**Historic District Review Committee
Staff Report
Date of Meeting: April 11, 2011
CAPP2011-0004
Historic District: Goose Creek
Project Planners: Lauren Murphy, Heidi Siebentritt**

CAPP 2011-0004 Leigh: New Addition to Non-historic Residence in the Goose Creek Historic District. PIN # 424-40-2692

Figure 1: Subject Property, 38755 Leighfield Lane

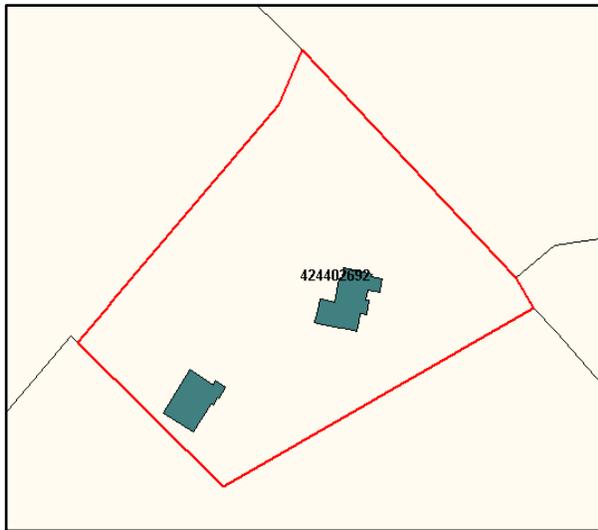
The subject property is located at 38755 Leighfield Lane in the Goose Creek Historic District.

The property is approximately 3 acres and is located on a private road accessible off of Mt. Gilead Road. The existing structure was built in 1998 and is not visible from any public right-of-way.
